**CITY OF SAN DIEGO  
M E M O R A N D U M**

SUBJECT: Project No. 84191 – Garfield Starbucks; Response to Planning Commission  
comments on June 21, 2007

REFERENCE: Planning Commission Report No. PC-07-091, dated June 14, 2007.

Enclosure: 1. Landscape Development Plan, Sheet 6 of 14

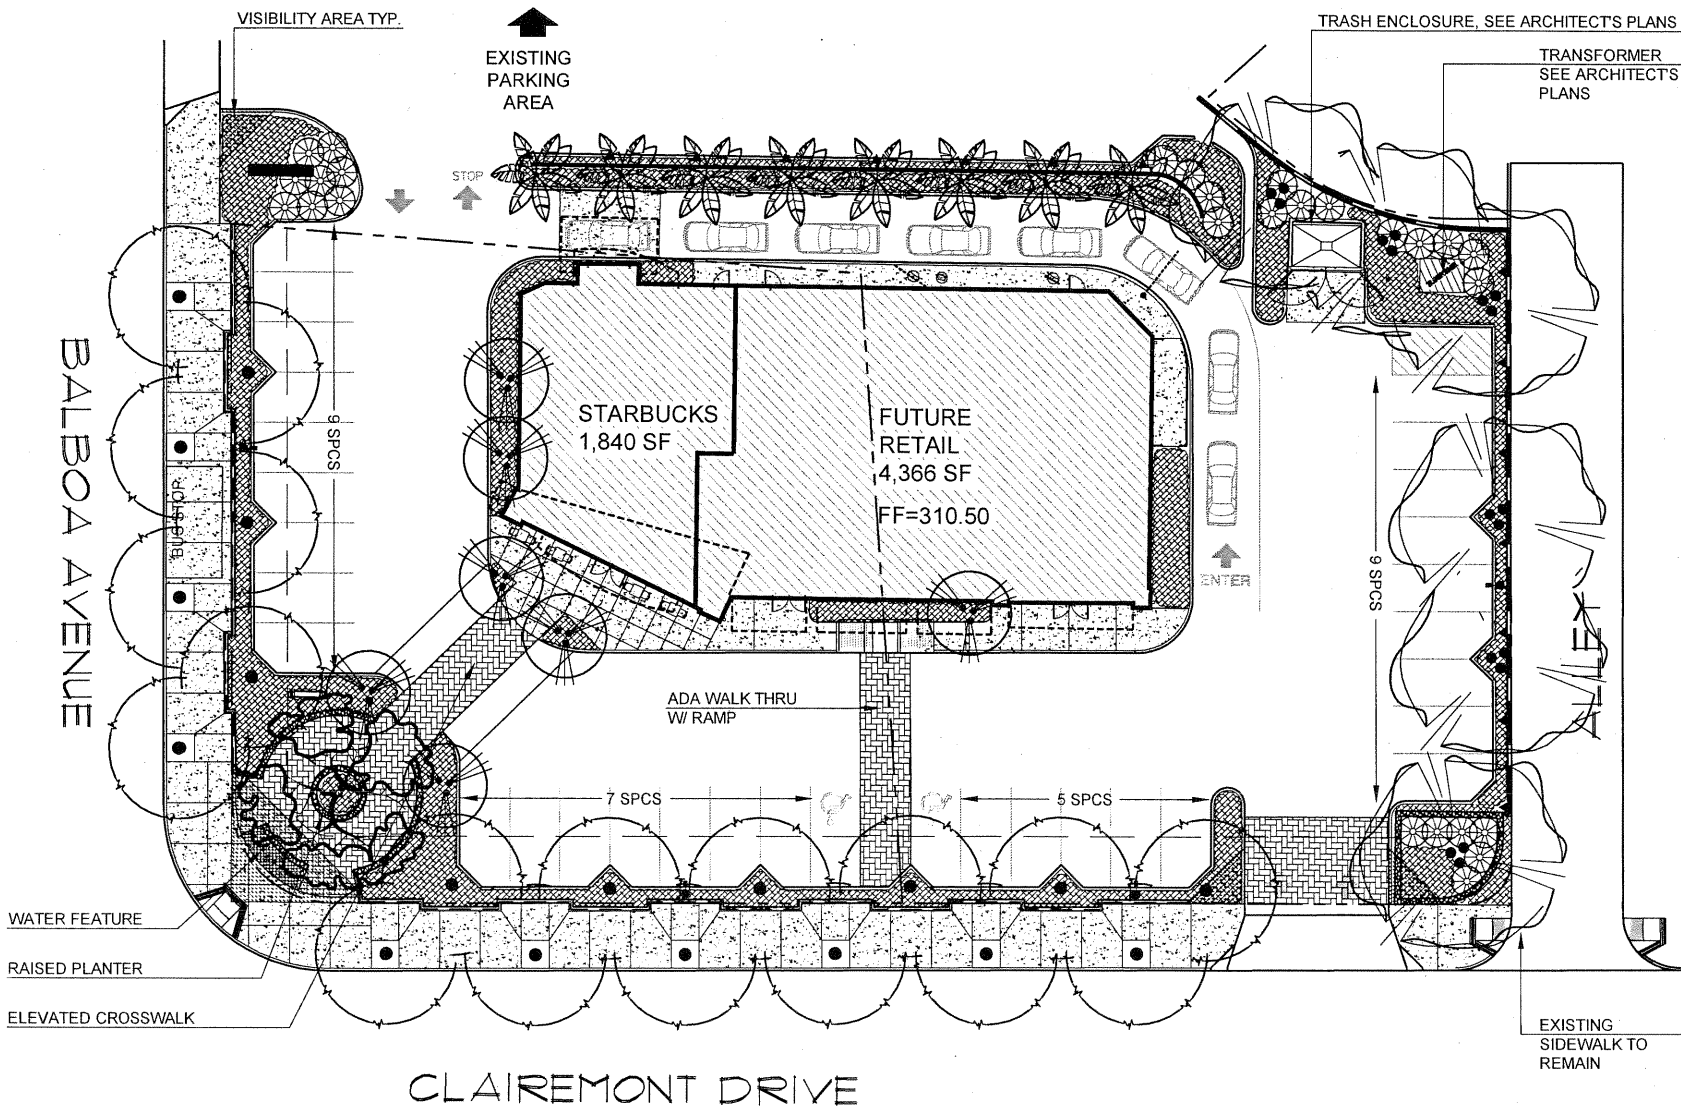
On June 21, 2007 the Planning Commission voted 6-0-1 (with one vacancy) to continue the Garfield Starbucks project to September 27, 2007 with direction that the applicant provide a solution that meets the objectives of the Draft Urban Design Element of the General Plan. Specifically, the Commissioners discussion regarding the siting of the building. The Commissioners' requested that the applicant look into the possibility of moving the building closer to the corner of Balboa Avenue and Clairemont Drive with parking behind the building.

The applicant considered the recommendations of the Planning Commission and has revised the proposed landscape plan to provide a wider canopy and additional screening from the adjacent streets to enhance both the pedestrian and dining experience of patrons of the Garfield Starbucks (Enclosure 1). Considering the noise levels from the busy streets, the applicant does not believe moving the Starbucks and its patrons closer to the corner would enhance either the pedestrian or dining experience as envisioned by the General Plan. In addition, the applicant proposes a fountain feature at their northwest property corner as a gateway monument to draw the public into the facility from the abutting streets.
